## 363 Cocoanut Row, Palm Beach, FL 33480

## REVISED LANDMARKS 04-06-2023

LPC# COA-23-002 (JANUARY 2023)

SINCE THE JANUARY LPC MEETING, THE PROJECT HAS RECEIVED APPROVAL FROM TOWN COUNCIL OF ALL VARIANCES, SITE PLAN APPROVAL & SPECIAL EXCEPTIONS

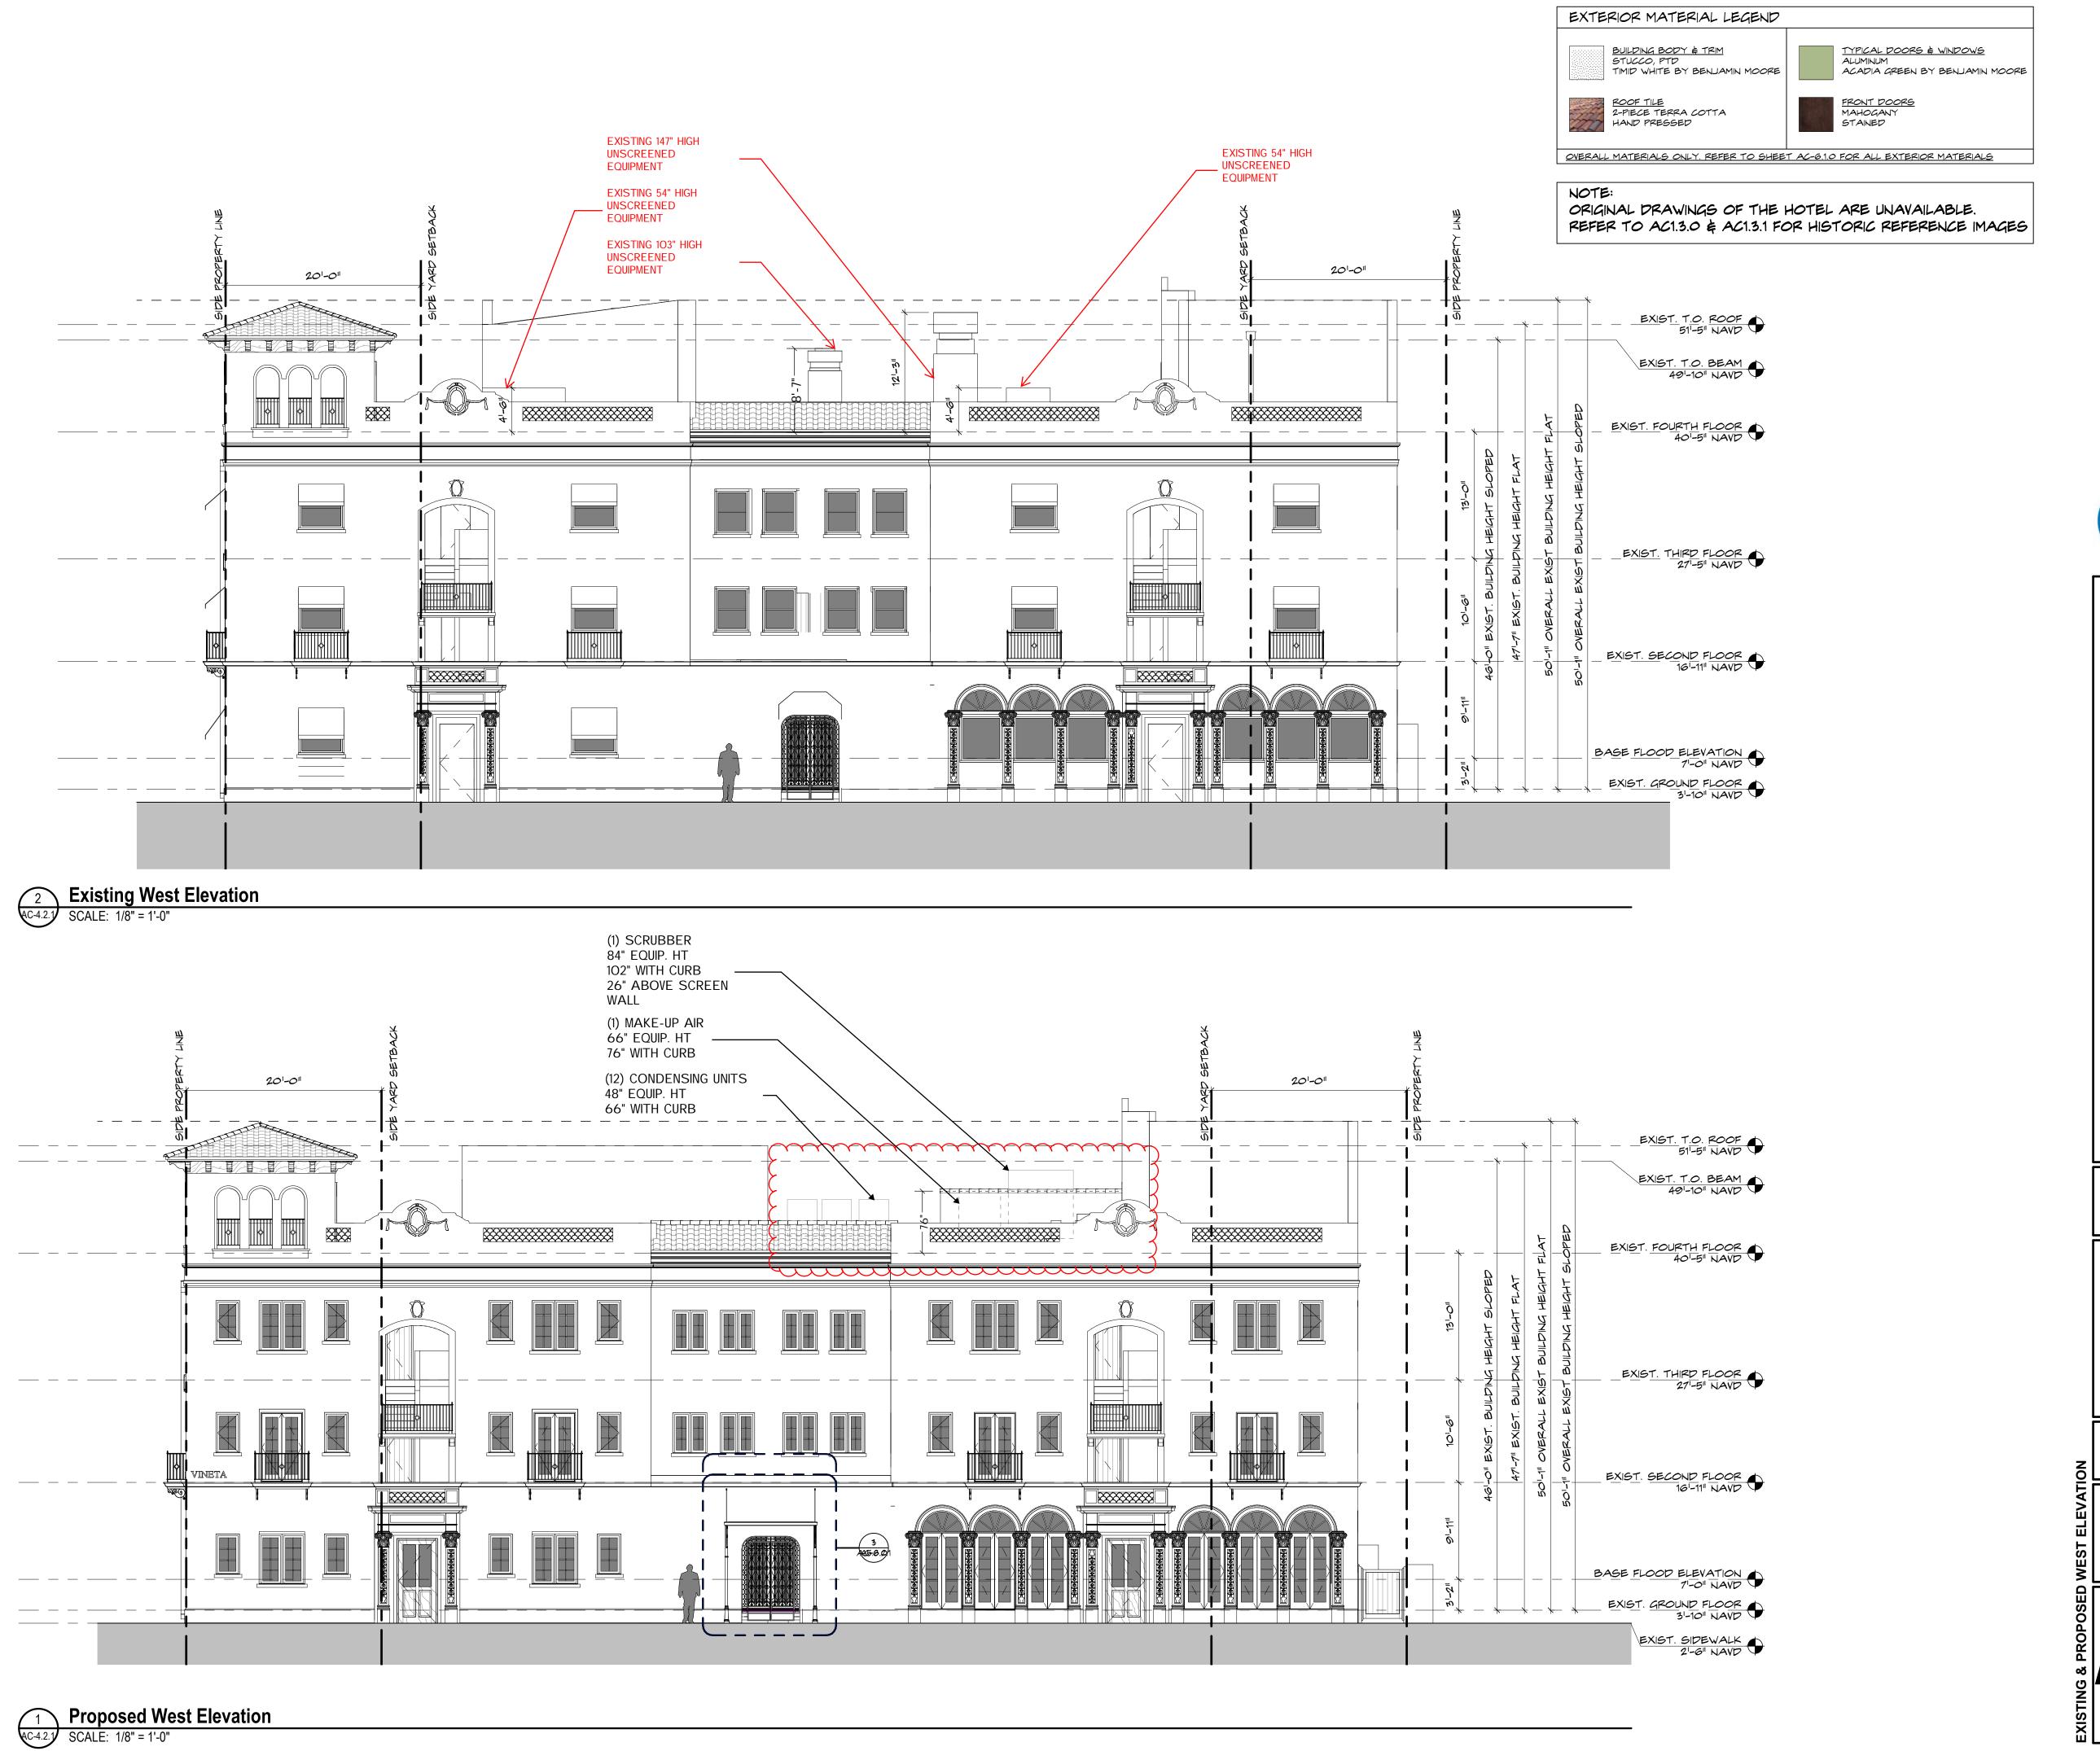
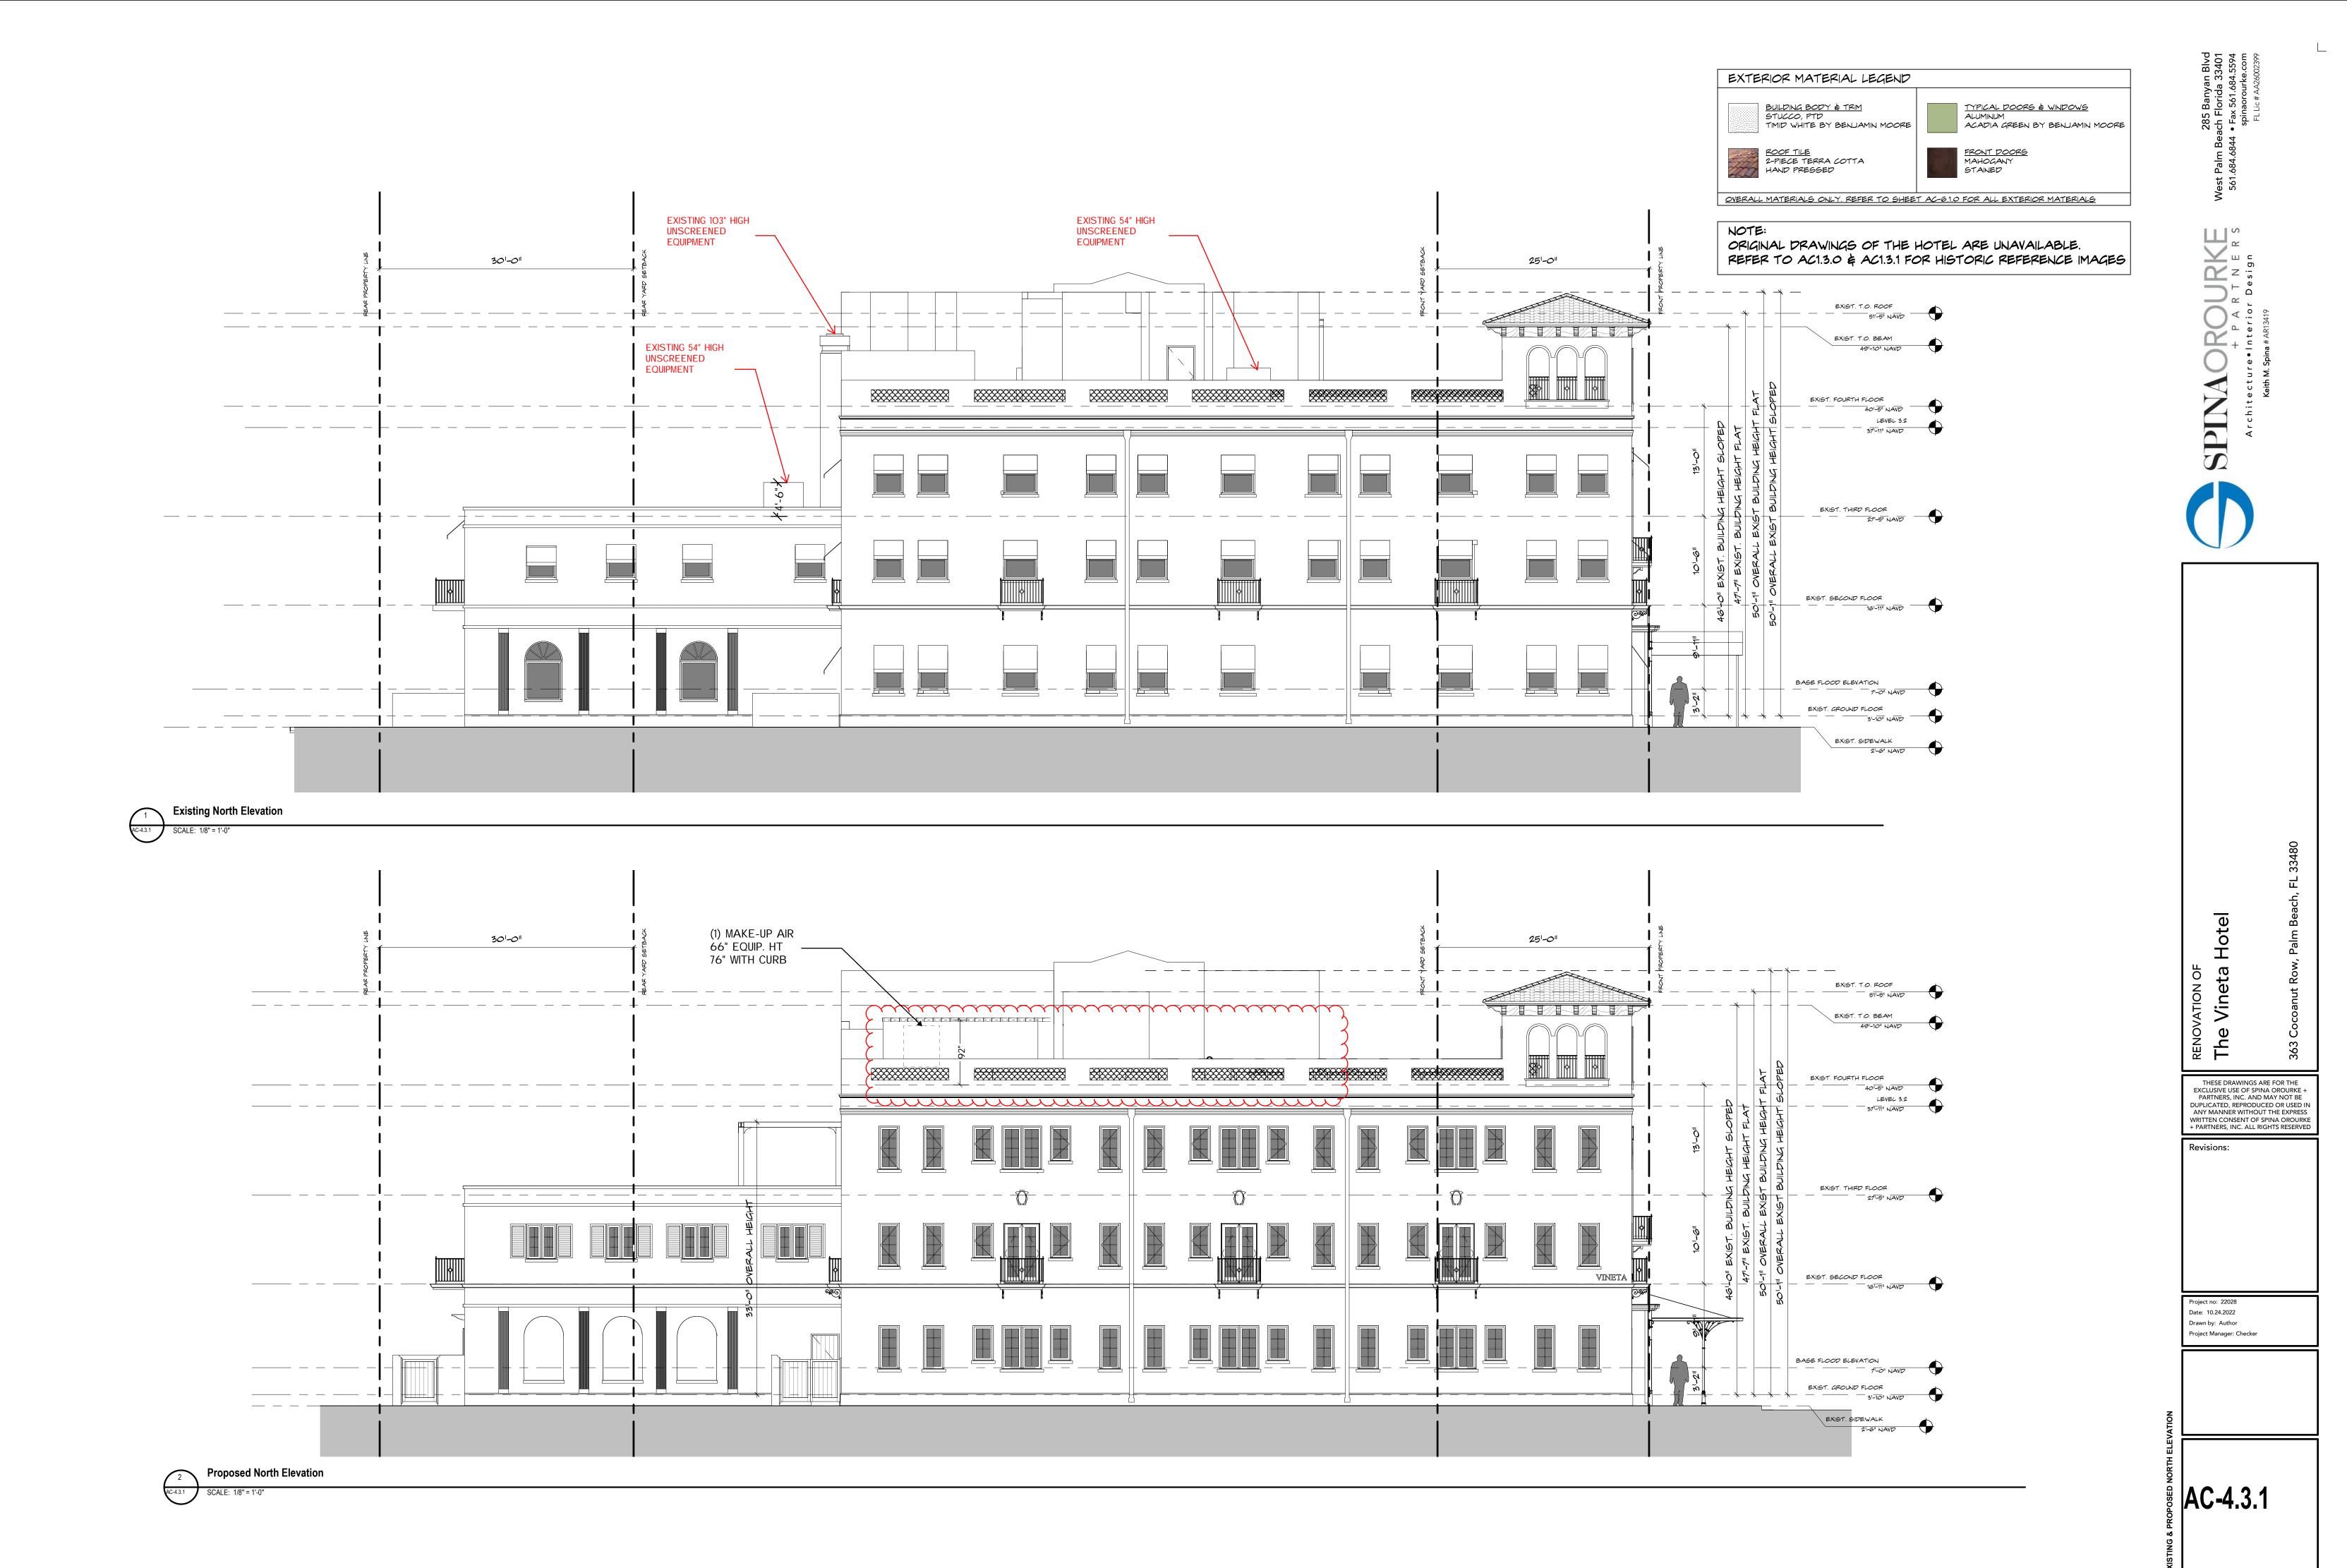
POOL LOUNGE FENESTRATION

PREVIOUSLY APPROVED FLOOR PLAN - NANAWALL

PREVIOUSLY APPROVED SOUTH ELEVATION - NANAWALL

PREVIOUSLY APPROVED EAST ELEVATION - SINGLE WINDOWS

PROPOSED FLOOR PLAN - (5) FRENCH DOORS

PROPOSED SOUTH ELEVATION - (5) FRENCH DOORS

PROPOSED EAST ELEVATION - DOUBLE WINDOWS
